May 8, 2023

RE: Comment Response Letter – The Village at Saddlerock Crossing - PZ19-00005 (ZC, DEV)

SITE PLAN

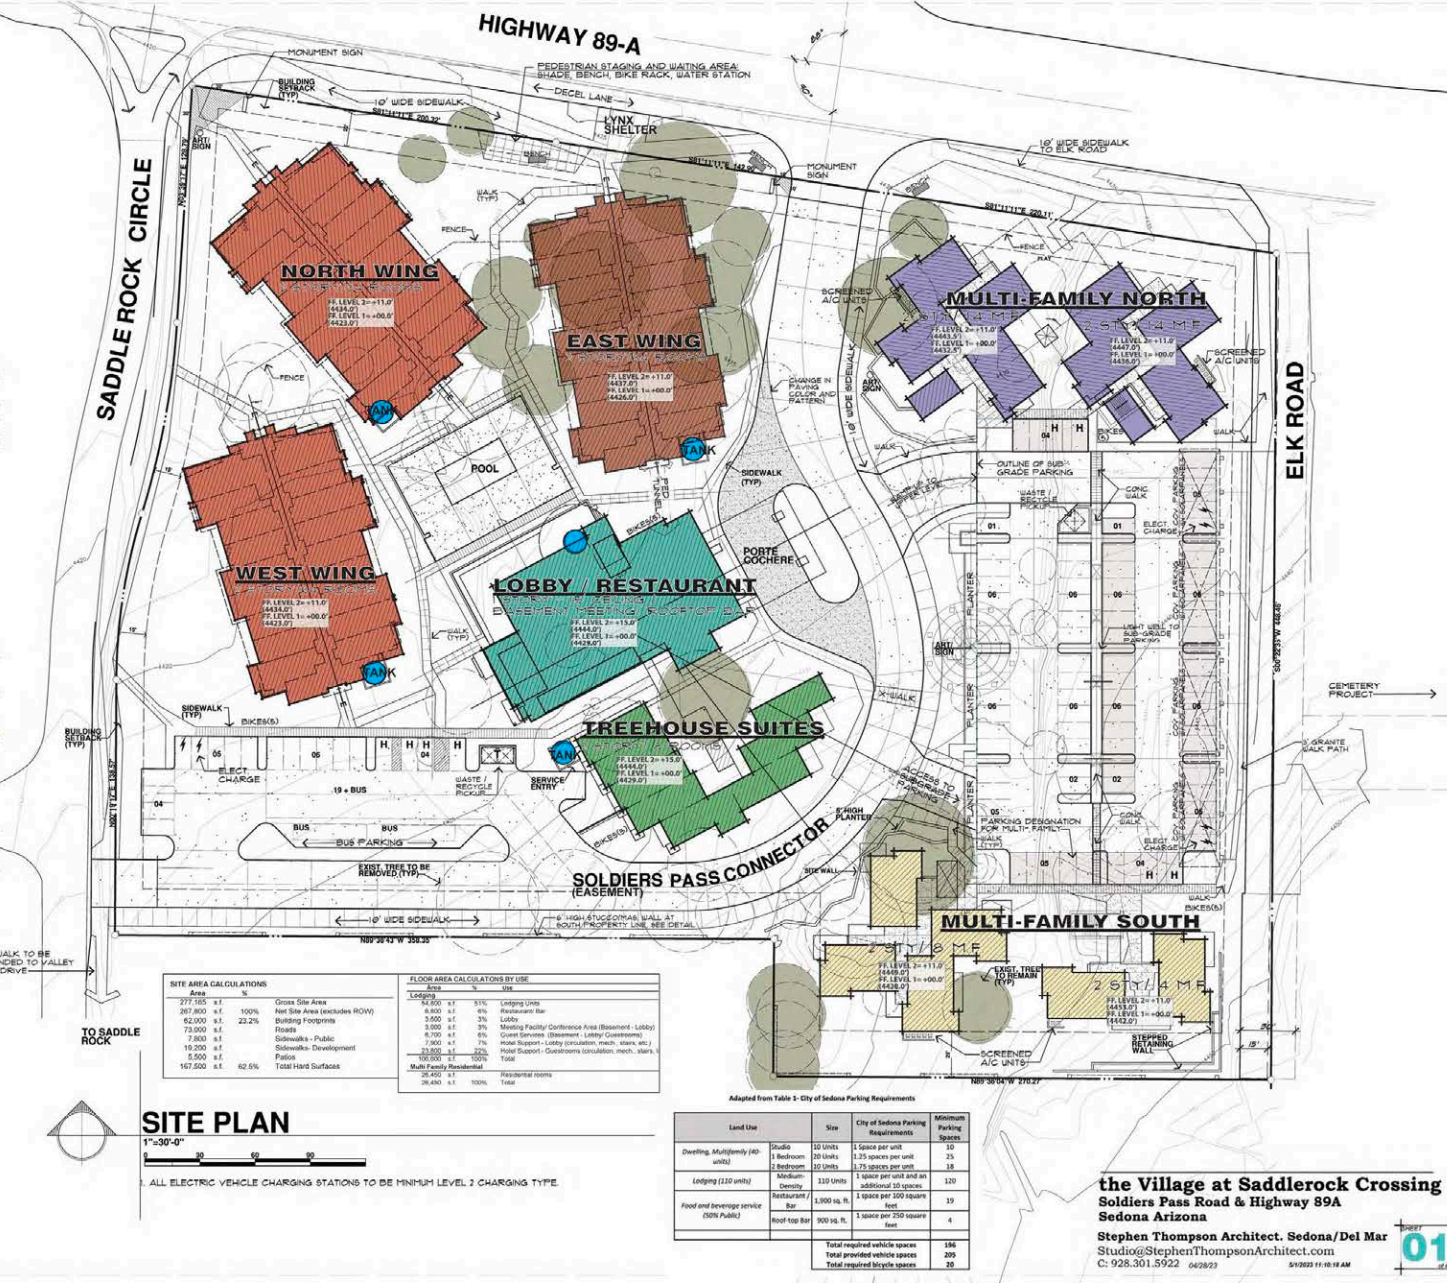
- i) Previous plans showed a connection to Elk Road, which is not on the current plans. A connection to Elk Road is needed to address the CFA goal of coordinated development. (CFA Page 10) This is also a requirement of LDC Section 5.4 (Access, Connectivity, and Circulation).

- ii) Include pedestrian connections from the street (Connector Road) to the multifamily units and the parking garage. (CFA Page 12, 17, 23) The Circulation Plan shows pedestrian connections from the sidewalk to the parking garage that are not shown on the Site Plan.

- a) Provide a calculation for total building footprint area and lot coverage.
 - i) *A total calculation for both square footage and percentage has not been provided.*

ii) *Walkways, driveways, pathways, pool areas, etc., are not included in the calculations.*

- b) Provide calculations for total building areas and percent of floor area devoted to each use.
- i) *The lodging area should be broken down into the different components – lodging rooms, restaurant, bar, meeting facility, etc.*

A pedestrian pathway/sidewalk has been added at the north end of the parking area east of the Connector Road, providing a pedestrian connection from the connector road to Elk Road.

Sidewalks have been added to site plan linking the Connector Road sidewalk to both of the multi-family clusters.

Calculations provided on Site Plan (Sheet 1)

Calculations provided on Site Plan (Sheet 1)

CFA-5 Lodging Area Limits (LAL) Map

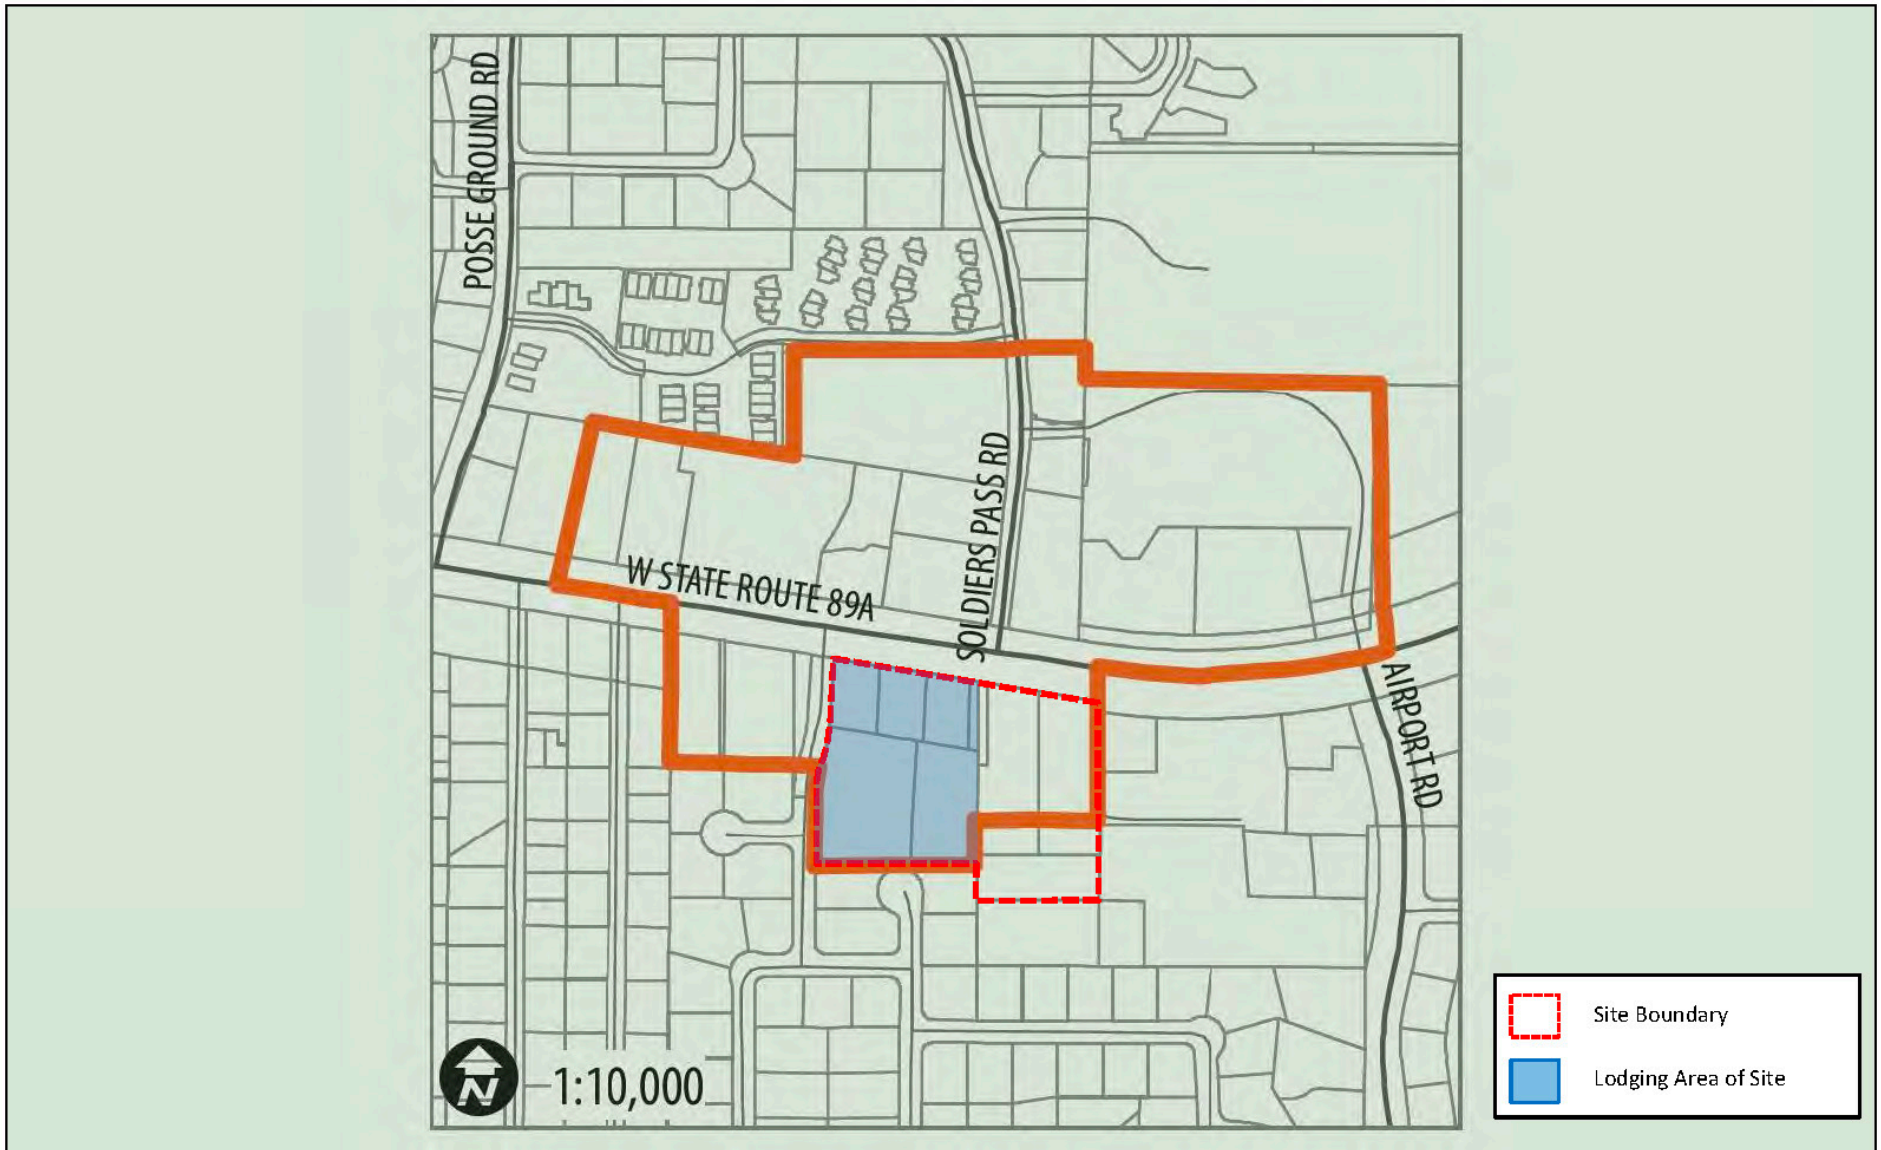
- iv) *Tab 7 in the LOI has not been updated.*

As noted above, the LOI incorporates the version CFA that was in effect at the time the application was originally submitted in April 2019.
